विषय:- जनपद नैनीताल में स्थापित राजकीय मेडिकल कॉलेज हल्द्वानी के नियन्त्रणाधीन स्वामी राम कैंसर चिकित्सालय एवं अनुराधान संस्थान हल्द्वानी का विस्तारीकरण करते हुए "राज्य कैंसर संस्थान" तथा संक्रमण रोग चिकित्सालय की स्थापना किये जाने हेतु 4.25 है० वन भूमि के हस्तान्तरण के सम्बन्ध में। (Online No. FP//UK/DISP/114282/2020)।

विषय:- राजकीय मेडिकल कालेज हल्द्वानी द्वारा 4.25 हे० वन भूमि हस्तान्तरण हेतु ऑनलाईन अपलोड किये गये प्रस्ताव संख्या- FP/UK/DISP/114282/2020 पर एम०ओ०ई०एफ० द्वारा लगायी गयी ई०डी०एस०।

विषय:- राजकीय मेडिकल कॉलेज हल्द्वानी में स्टेट कैंसर संस्थान की स्थापना किए जाने के सम्बन्ध में।

PROPOSED SITE PLAN OF STATE CANCER INSTITUTE AT HALDWANI DIST: NAINITAL
TOTAL LAND 4.25 HECTARE

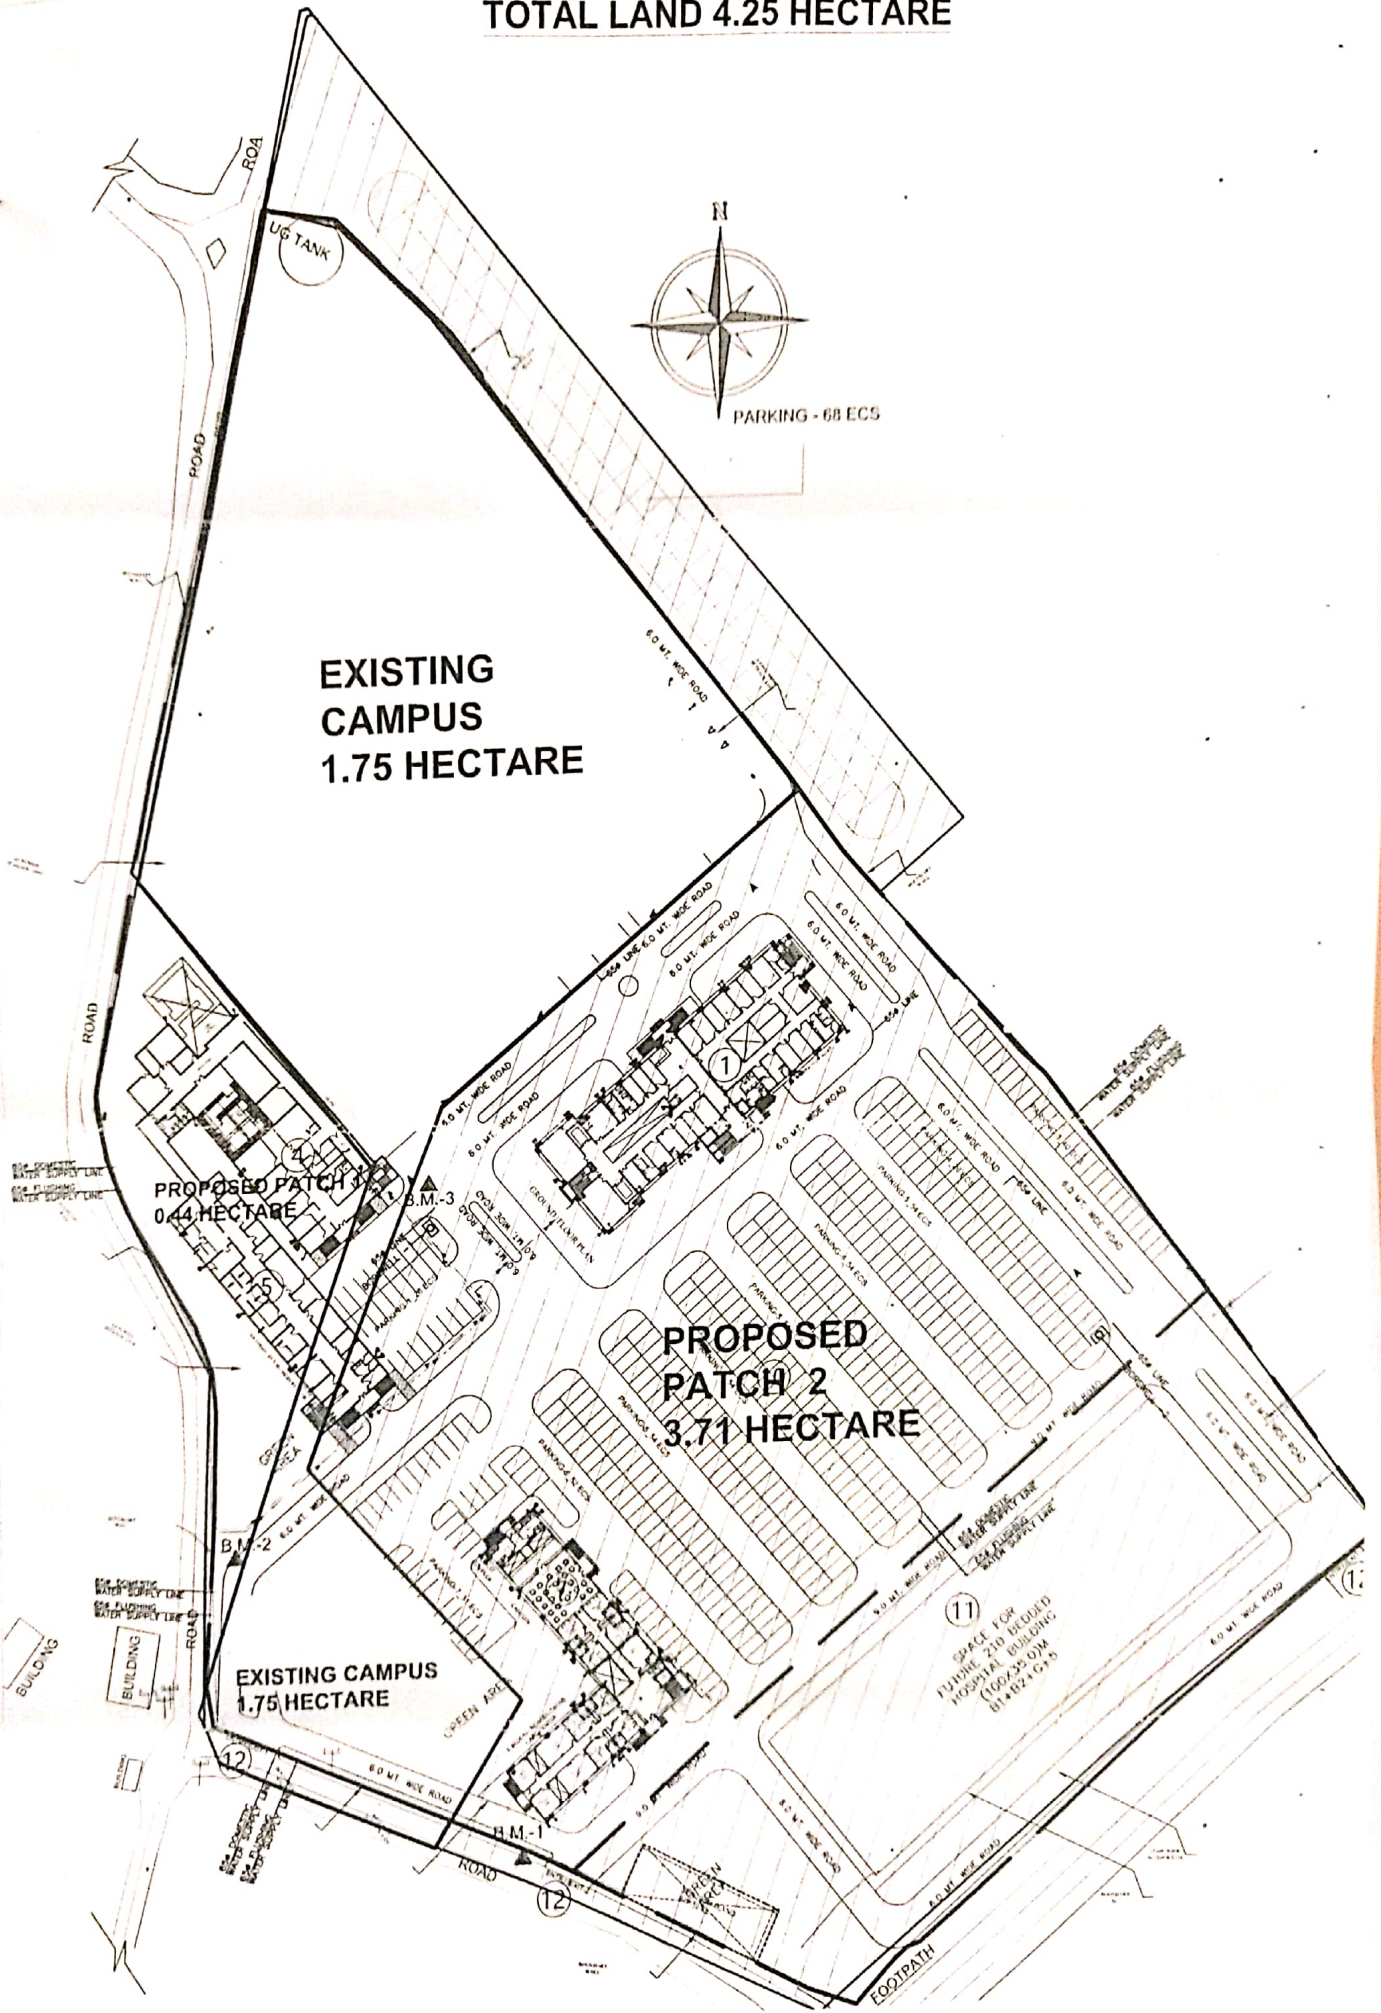
10. प्रस्ताव में 3.71 है0 Patch का lay-out प्रस्ताव नहीं किया गया है। अतः राज्य सरकार से अनुरोध है कि वह दोनो Patches में Lay-out प्रकार करें ताकि कम-से-कम वृक्षों को काटे जाने की आवश्यकता रहे।	10- The required layout map/concept plan of proposed land is being uploading herewith. The layout has been proposed so that felling of minimum number of trees is required.

1. **बिन्दु संख्या 9:-** परियोजना हेतु प्रस्तावित भूमि समतल होने के कारण कोई पहाड़ कटान का कार्य किया जाना प्रस्तावित नहीं है। परियोजना के किसी भी भवन में बेसमेन्ट का प्राविधान नहीं किया गया है। परियोजना के अन्तर्गत भवन में केवल नींव खुदाई का कार्य ही प्रस्तावित है। नींव खुदाई से प्राप्त मिट्टी की मात्रा को भवन की बैकफिलिंग में उपयोग में लाया जाएगा, जिसके दृष्टिगत परियोजना के निर्माण में Muck Disposal की आवश्यकता नहीं होगी। इस कारण Muck Disposal Plan संलग्न नहीं किया गया है।
2. **बिन्दु संख्या 10:-** परियोजना के अन्तर्गत प्रस्तावित भवनों, आन्तरिक सड़कों एवं पार्किंग को दर्शाते हुए सम्पूर्ण भूमि पर परियोजना का ले-आउट प्लान/कॉन्सेप्ट प्लॉन संलग्न कर प्रेषित किया जा रहा है।
